**DEVELOPMENT REVIEW BOARD MEETING  
APRIL 10, 2023  
6:30 PM**

**DEVELOPMENT REVIEW BOARD  
RESOLUTION NO. 413**

Exhibit A1  
Staff Report  
Wilsonville Planning Division  
Precision Countertops  
Development Review Board Panel 'A'  
Quasi-Judicial Public Hearing

<b>Hearing Date:</b>	April 10, 2023
<b>Date of Report:</b>	April 3, 2023
<b>Application No.:</b>	DB22-0011 Precision Countertops
<b>Request/Summary:</b>	The requests before the Development Review Board include a Stage 1 Preliminary Plan, Stage 2 Final Plan, Site Design Review, Waiver, Class 3 Sign Permit, and Type C Tree Removal Plan.
<b>Location:</b>	25540 SW Garden Acres Road. The property is specifically known as Tax Lot 500, Section 2C, Township 3 South, Range 1 West, Willamette Meridian, Washington County, Oregon
<b>Owner/Applicant:</b>	PCT NW Properties OR, LLC, dba Precision Countertops, Inc. (Contact: Robert Hausserman)
<b>Authorized Representative:</b>	MDG Architecture/Interiors (Contact: Simone O'Halloran)
<b>Comprehensive Plan Designation:</b>	Industrial
<b>Zone Map Classification (Current):</b>	Future Development 20 Acre (FD-20; Washington County)
<b>Zone Map Classification (Proposed):</b>	Planned Developme

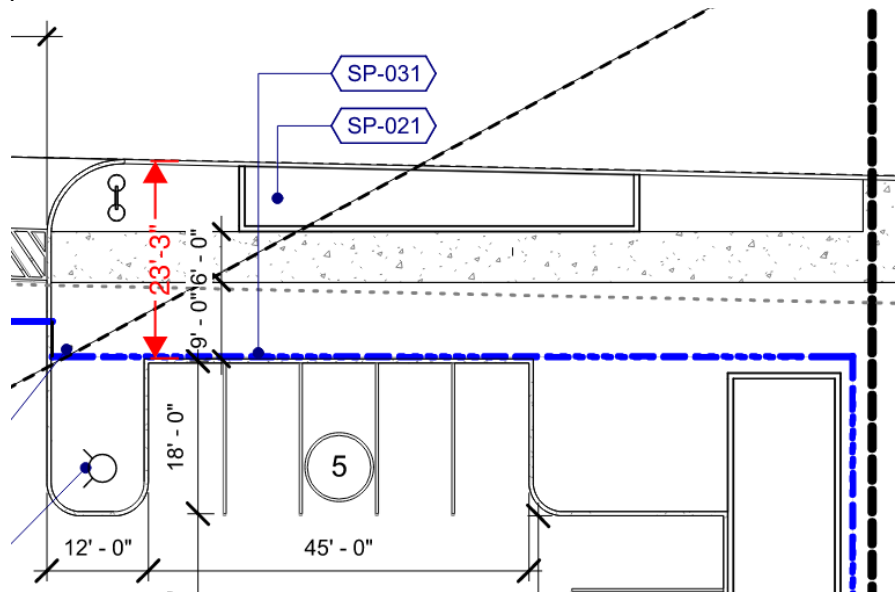
- C. Provide sufficient findings and materials addressing standards of the Coffee Creek Industrial DOD including, but not limited to, the following:
  - a. Table CC-3 Site Design, 2. Parcel Pedestrian Access, General. Explain how separate and direct pedestrian connections between parking, entrances, and street right-of-way are provided along the Supporting Street between the Addressing Street and the east portion of the site not currently proposed for development. Staff notes that the sidewalk along the Supporting Street doesn't directly connect to the Addressing Street right-of-way or extend to the east past the proposed development area.

**Response:** The following excerpt from the proposed site plan illustrates the extension of the sidewalk past the proposed development area to the east. An additional pedestrian connection has been added along the supporting street to allow direct access to the addressing street right-of-way. A painted pedestrian path has been added where the connection crosses the west parking lot drive aisle.

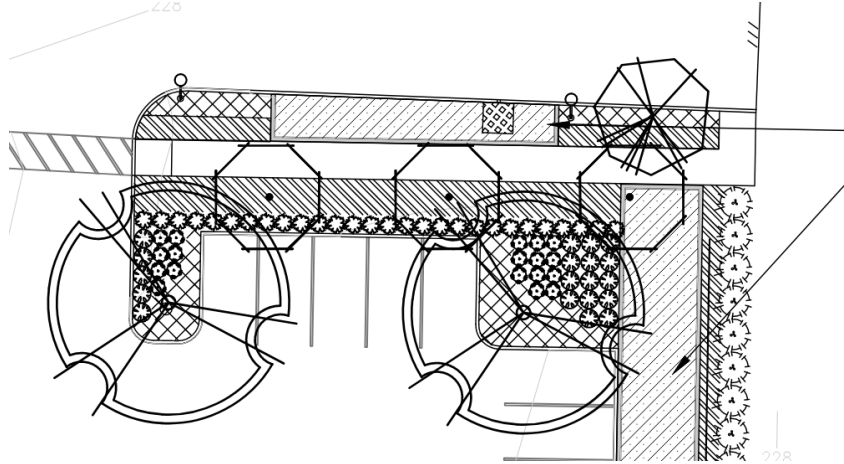
- c. Table CC-3 Site Design, 4. Parking Location and Design, Parking Lot Sidewalks and Parking Perimeter Screening and Landscaping. Demonstrate how the minimum 9-foot depth for planted areas adjacent to off-street parking areas and the General Landscape Standard or Low Berm Standard (see Section 4.176 (.02) C. and F.) are met for the east parking area on the Supporting Street. There doesn't appear to be any landscaping to screen parking from the Supporting Street in this area, as the sidewalk is curb-tight to the parking.

**Response:** The proposed development includes a 9ft landscaped planted area adjacent to the northeast parking area on the

*Supporting Street. Dimension has been added to A1.1 noting the depth of landscaped area. The following exhibit shows that all General Landscaping standard have been met.*

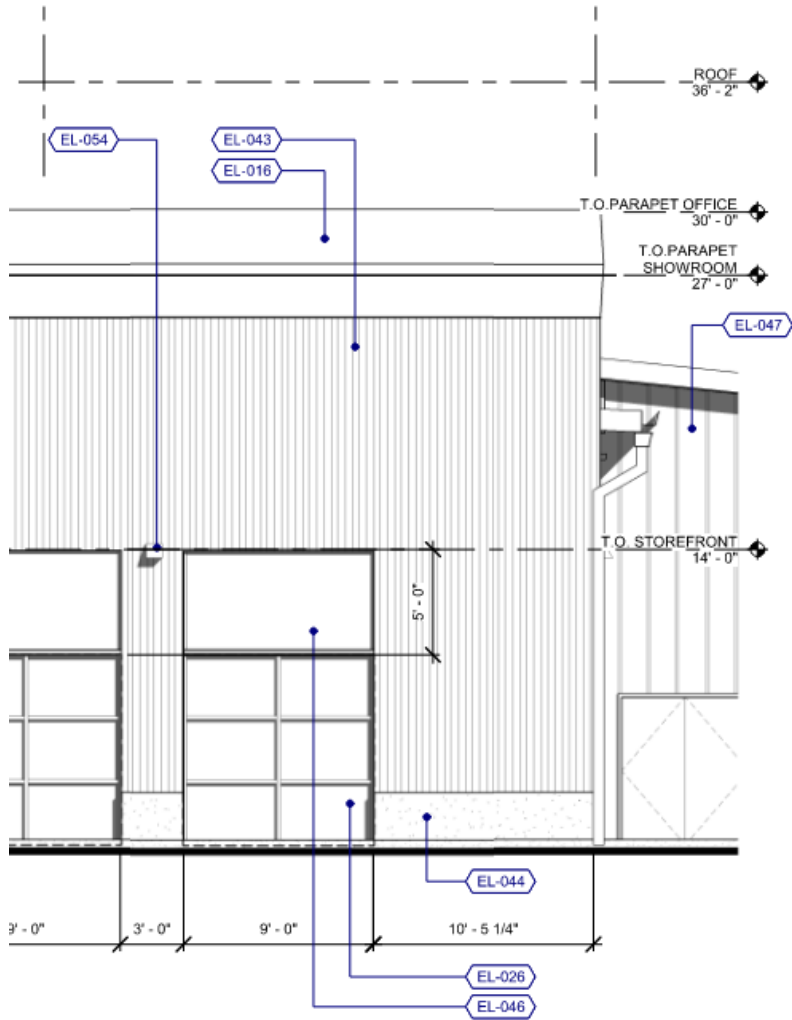
- d. Table CC-3 Site Design, 5. Grading and Retaining Walls, Maximum Height, Required Materials, Retaining Wall Design. Demonstrate how the standards are met for the retaining wall along the Supporting Street shown on Sheet C3.0.

**Response:** *The proposed development has been revised, removing all retaining walls along the Supporting Street. Requirement no longer applied.*

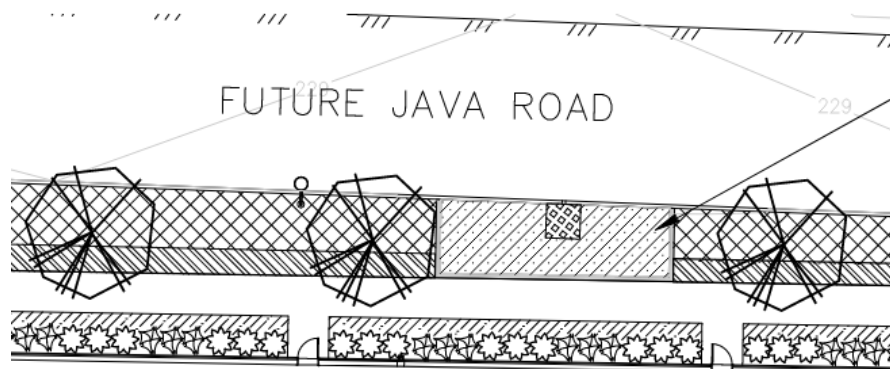
- G. Demonstrate how the sidewalk along the Supporting Street is separated from the building in accordance with Figure CC-2 (Section 4.134(.10)). Demonstrate how required street trees are provided on the Supporting Street. Consider using narrower stormwater planters in lieu of proposed rain gardens along the Supporting Street as they allow the sidewalk to be separated from the building with landscaping. Extend the sidewalk to the east boundary of the developed area of the site in addition to extending it to the parking area as shown on the plans.

**Response:** The proposed development has been revised to address Figure CC-2, Section 4.134 through reconfiguring the stormwater planters in lieu of rain gardens. This approach allows for more dimension for street trees and separated sidewalk along the Supporting Street.

**TREE REMOVAL AND PROTECTION PLAN**

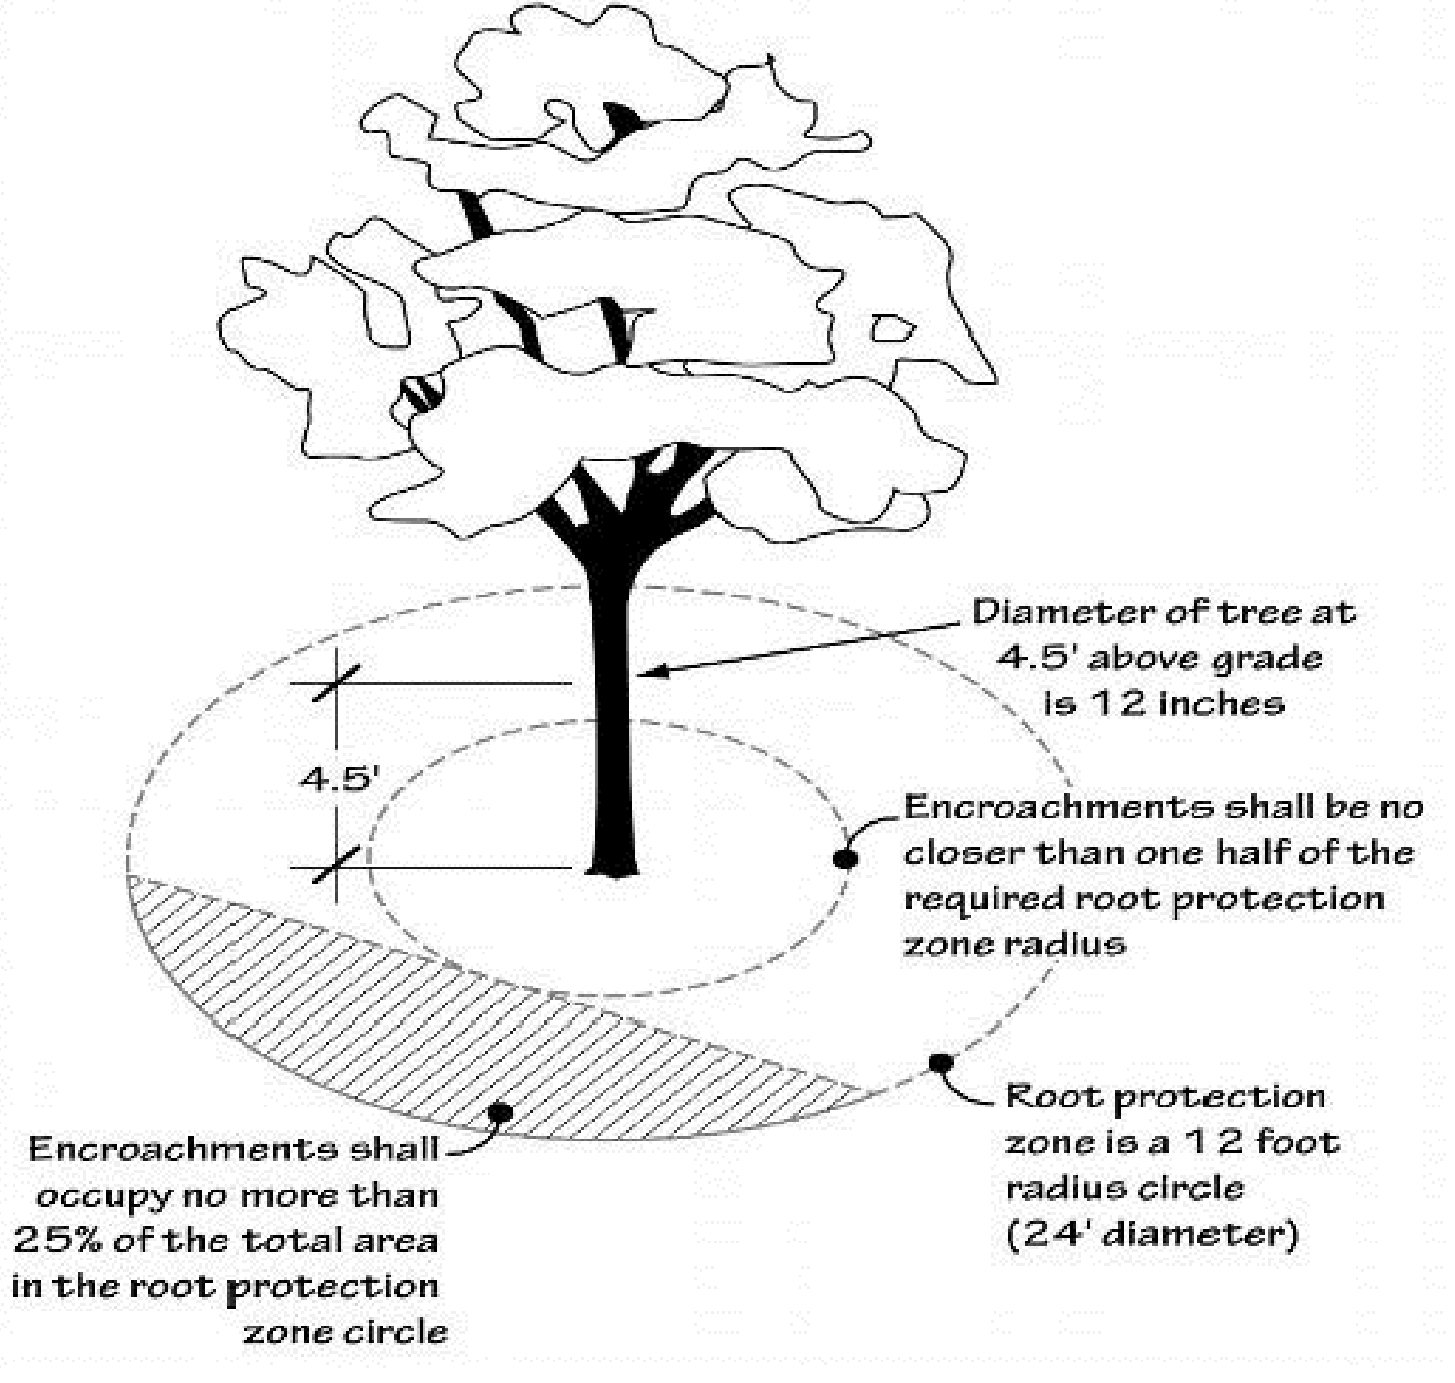
- B. Include a column in the tree survey table on Sheet L1.1 that indicates for each tree whether it will be removed or retained.

**Response:** Sheet L1.1 includes the Tree Inventory Table from the Arborist Tree Survey. The table now includes a column indicating whether the tree is slated for remove or to be retained.

**Response:** *The landscape plan (L1.1) has been updated to illustrate the existing trees from the survey and trees to remain.*
